# **AGENDA**

## **DESIGN REVIEW COMMITTEE**

**October 9, 2018**

DR18-01 Design Review DR18-01 by Craig Riegelnegg, Carleton Hart Architecture for Hollander Hospitality to construct an approximate 29,782 square foot, four story hotel, adjacent to historic structures, at 1 2<sup>nd</sup> Street (Map T8N R9W Section 7DA, Tax Lots 11800 and 11900; Lots 1, 2, 3, 4, Block 1, McClure; and Map T8N R9W Section 7DB, Tax Lots 1300, 1400, 1501, 1700; Unplatted lots fronting on Block 1, Hinman's Astoria) in the C-3 Zone (General Commercial), Bridge Vista Overlay Zone (BVO), Flood Hazard Overlay (FHO), and CRESO Zone.

“Building Sections”

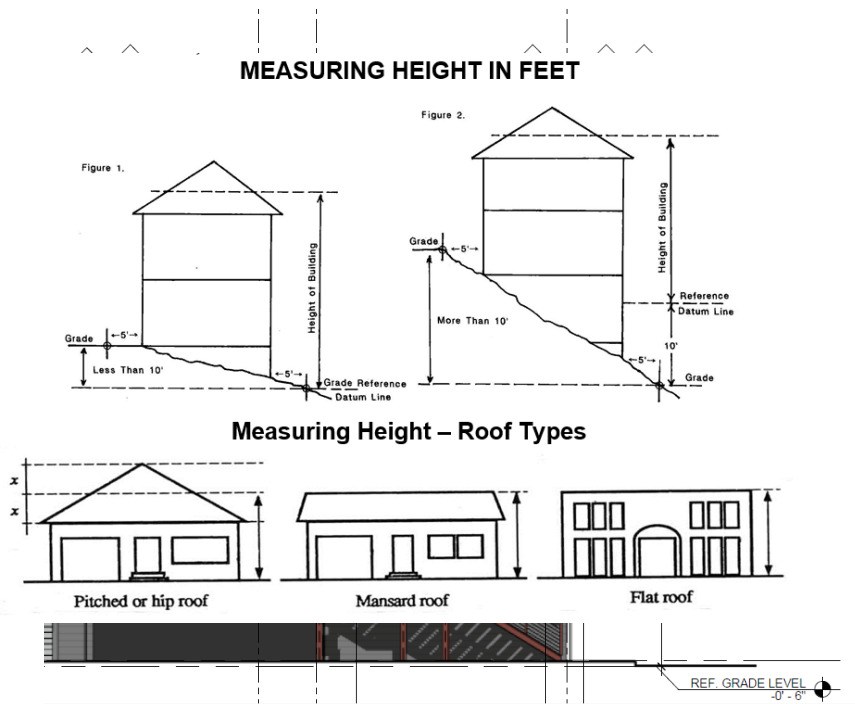
Finding: The applicant has addressed height on page 5 of the narrative citing from definitions of Section 1.400 of the Development Code. They have also included figures on

showing the height of the building, using the west side of the building for the lowest data point for measuring height.

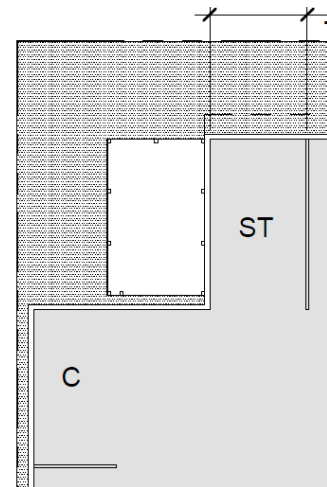
Finding: The garbage enclosure and enclosure around a transformer incorporates materials used elsewhere on the site. While not required, the addition of a man door to these enclosures could potentially help with noise abatement as an alternative to accessing the large gate. Additional landscaping or materials to soften the appearance would also be appropriate due to their high visibility on the site and from the Riverwalk.

The current proposal for the trash enclosure includes an operable gate that swings out, and no man door. The parking space noted to the right "c" is a compact space which has required dimensions of 8.5' x 16'. A "st" standard space is 9.5' x 20'. The applicant shall confirm access to and operation of the trash enclosure will not interfere either adjacent parking spaces.

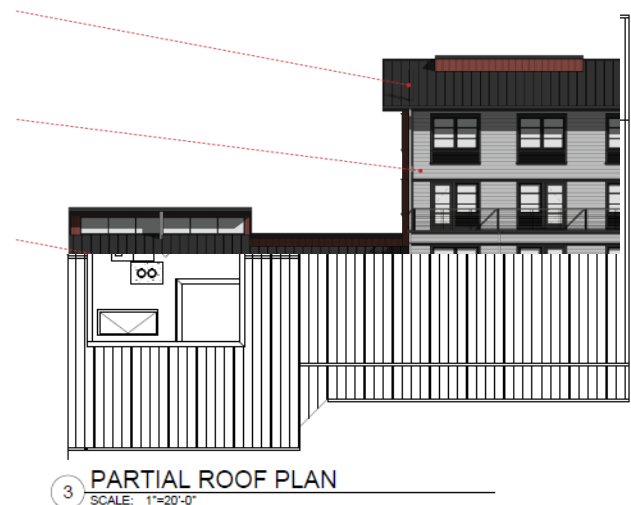
The applicant has submitted site lines for the rooftop elements noted on page 65. Pedestrians along the Riverwalk will not likely see rooftop elements, however the applicant did not include distances to the east-west, including the potential to view rooftop elements from the 2<sup>nd</sup> street Right of Way, which includes the pedestrian access point to the Riverwalk closest to the site. That being said screening has been included and setbacks or screening are deemed acceptable.

Four types of rooftop equipment units are proposed: HVAC units over the dining area, kitchen area, fitness area, and above guestroom corridors. Each unit is 3-4' wide and 4' high. The height of the units on top of Ship Inn range from 2.5' to 4' high. A partial roof plan shows the units screened, and tucked under the clerestory section of windows on the reception area.
